ADDENDUM NO. 01

Millard Public Schools
Cottonwood Elementary – Secure Vestibule Addition
615 Piedmont Dr. Omaha, NE
BCDM Project No. 3008-11

October 14, 2026

SHEET G0-1

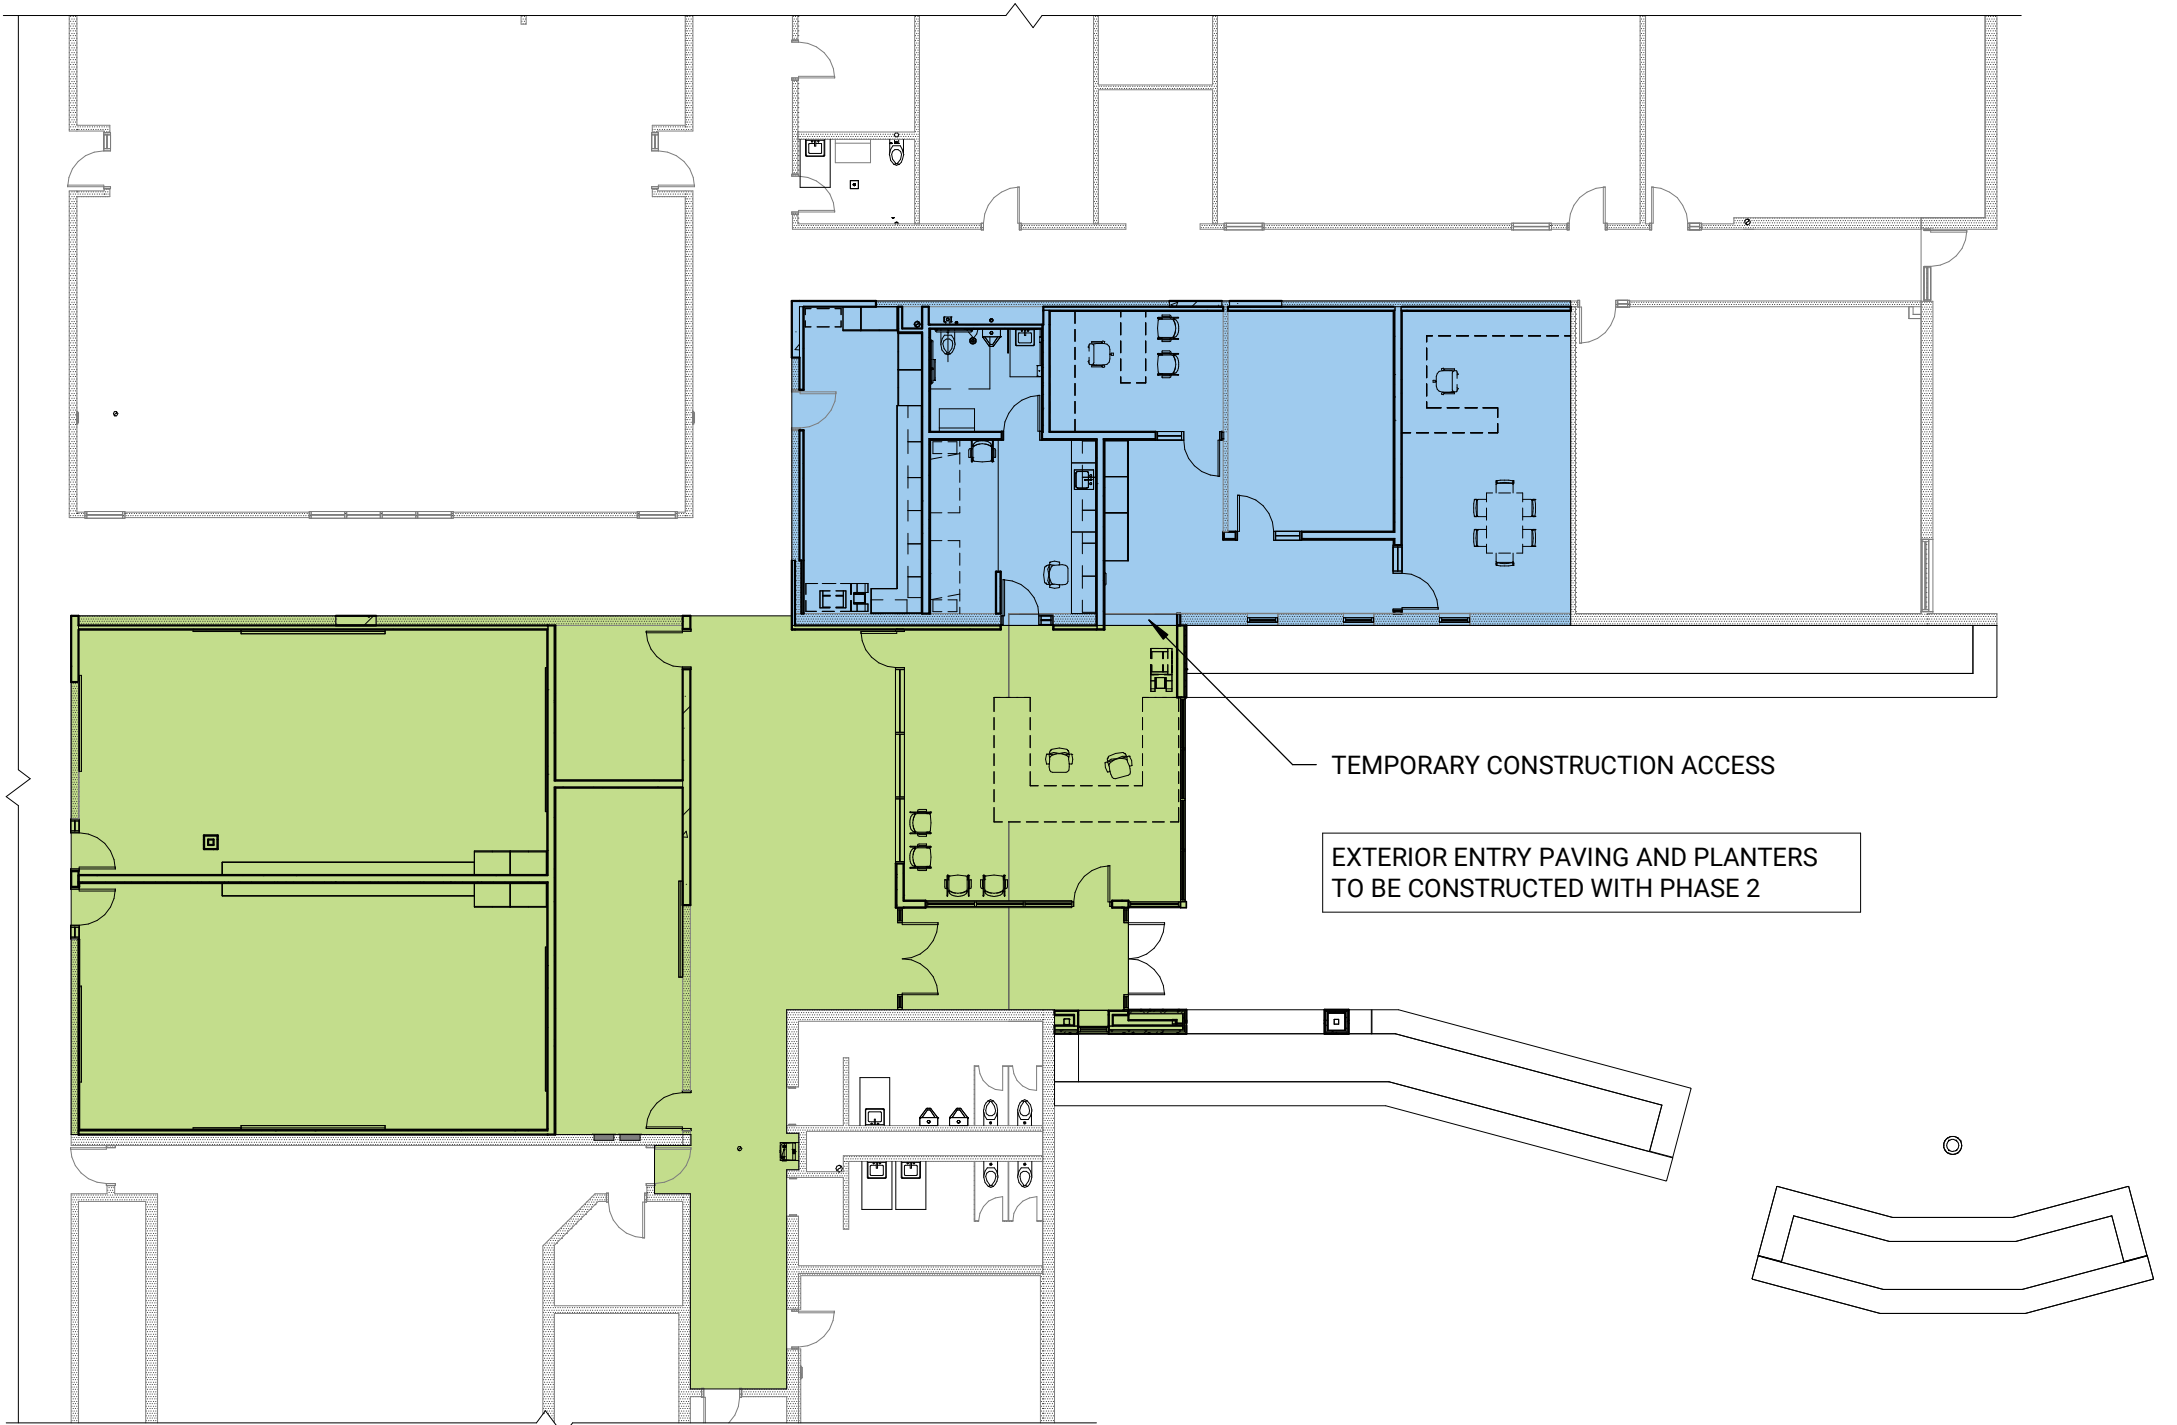
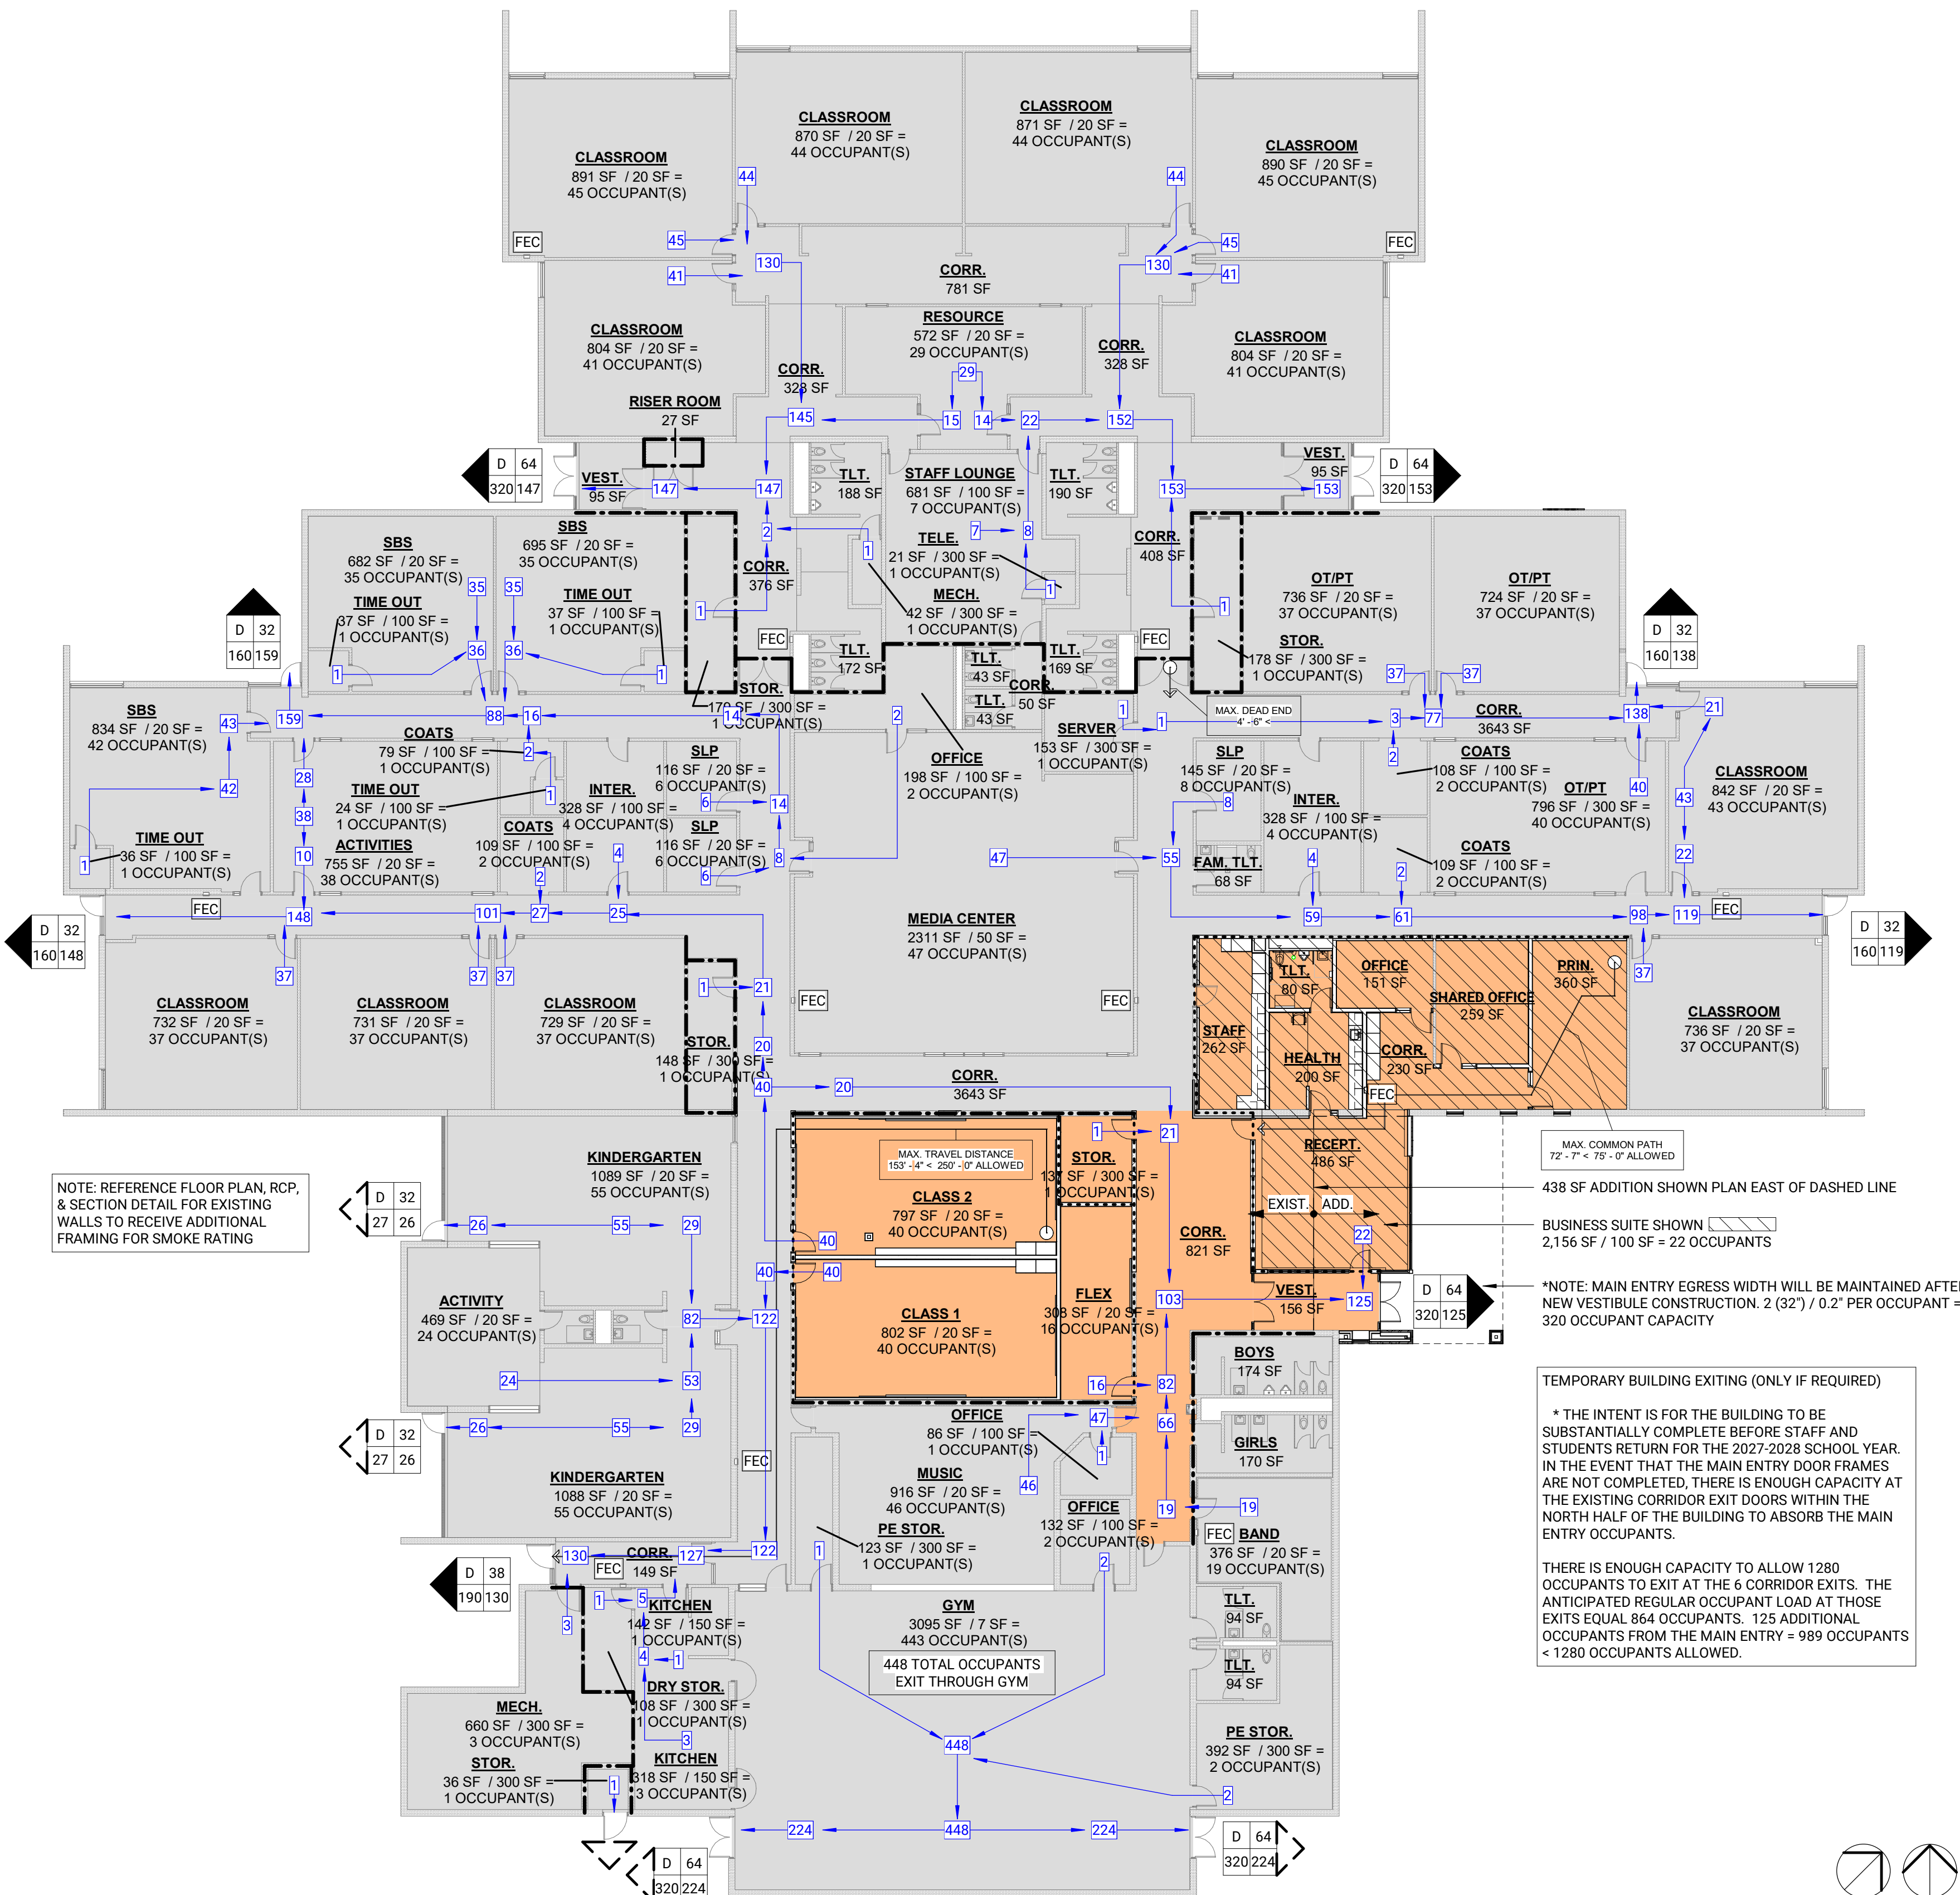
- a. Update General Phasing Notes as shown on the attached drawing.

GENERAL PHASING NOTES:

- THE SCHOOL WILL REMAIN FULLY OPERATIONAL DURING THE SCHOOL YEAR. THERE WILL BE LIMITED STAFF IN THE BUILDING DURING SPRING BREAK. EXISTING CLASSROOMS 53 AND 56 WILL BE EMPTY BY OR BEFORE APRIL 3.
- DURING THE SUMMER, THERE WILL NOT BE SUMMER SCHOOL. THERE WILL BE LIMITED STAFF WITHIN THE FACILITY.
- THE PHASING PLAN BELOW IS THE ANTICIPATED PHASING AS IT RELATES TO THE BUILDING EXITING REQUIREMENTS, AND WHICH SPACES ARE OCCUPIED OR AVAILABLE FOR CONSTRUCTION. IT IS THE CONTRACTORS RESPONSIBILITY TO ESTABLISH THE COMPLETE CONSTRUCTION PHASING SCHEDULE IN ACCORDANCE WITH THE BID DOCUMENTS.
- APPLICABLE SCHOOL CALENDAR DATES:
MPS SPRING BREAK: APRIL 5 - 9, 2027
LAST DAY OF SCHOOL: MAY 26, 2027
FIRST DAY OF SCHOOL: AUGUST 12, 2027

5 SECTION DETAIL AT SKYLIGHT INFILL

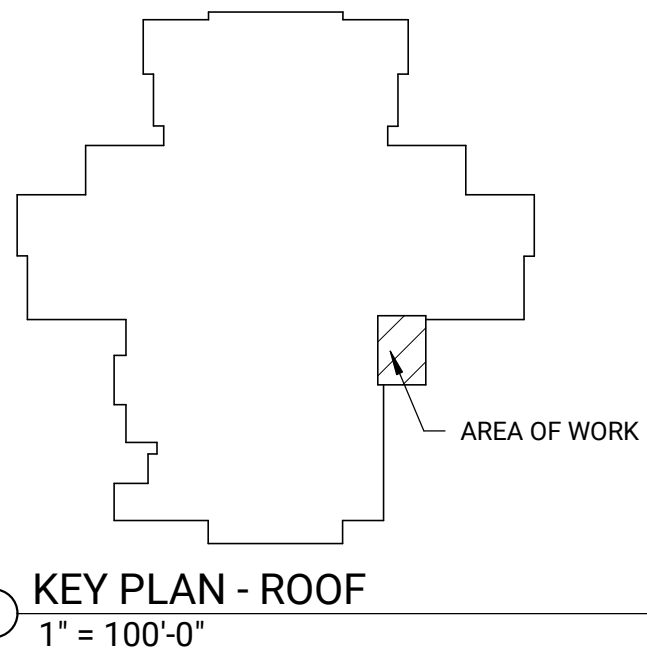
- a. Update 5/A1-2 to read “1/2” Coverboard” as shown on the attached drawing.

EPDM MEMBRANE
1/2" COVERBOARD
(2) LAYERS OF 2.6" RIGID INSULATION
NEW MTL. DECK TO MATCH EXISTING
SEE STRUCT.

SHEET A6-0

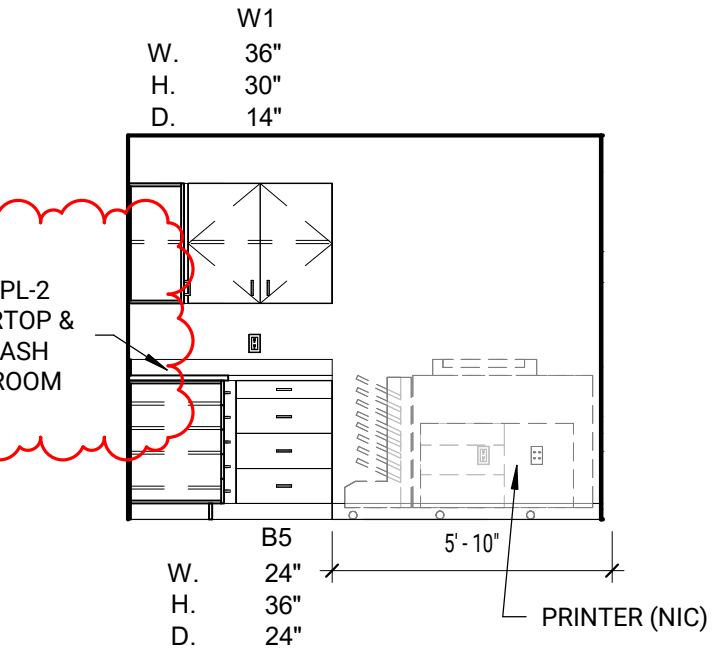
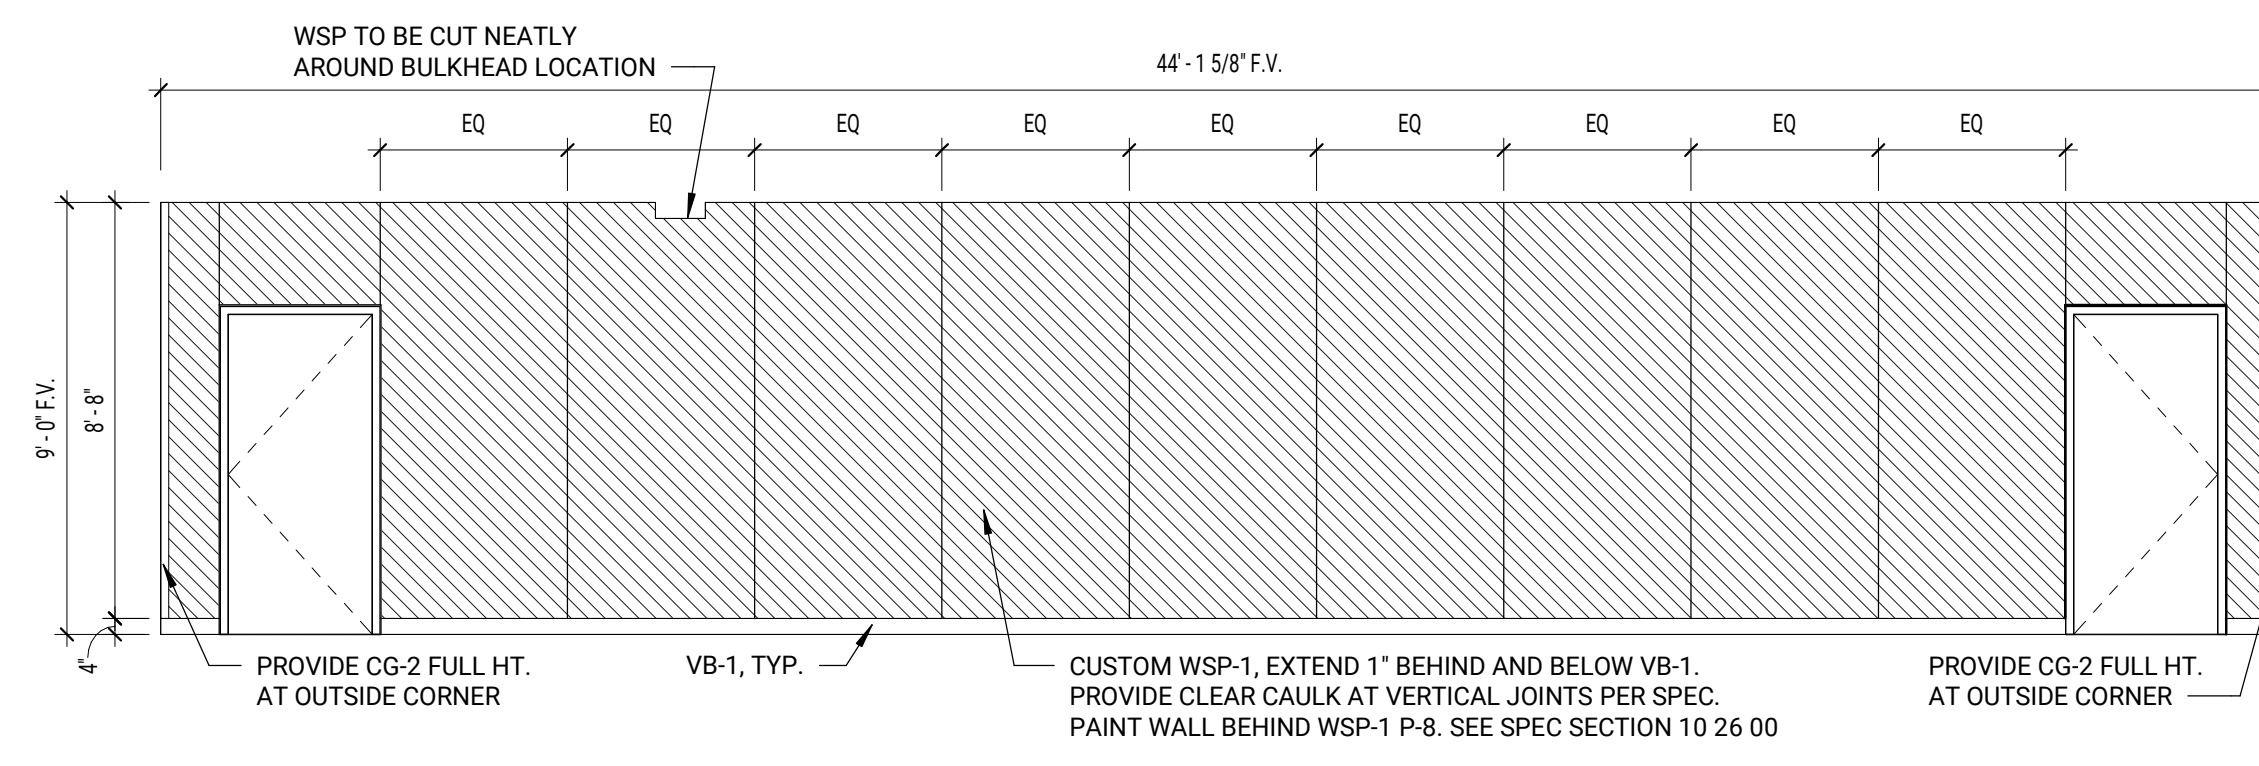
- a. Add “Provide PL-2 countertop & backsplash at this room” to 3 & 4/A6-0 as shown on the attached drawing.
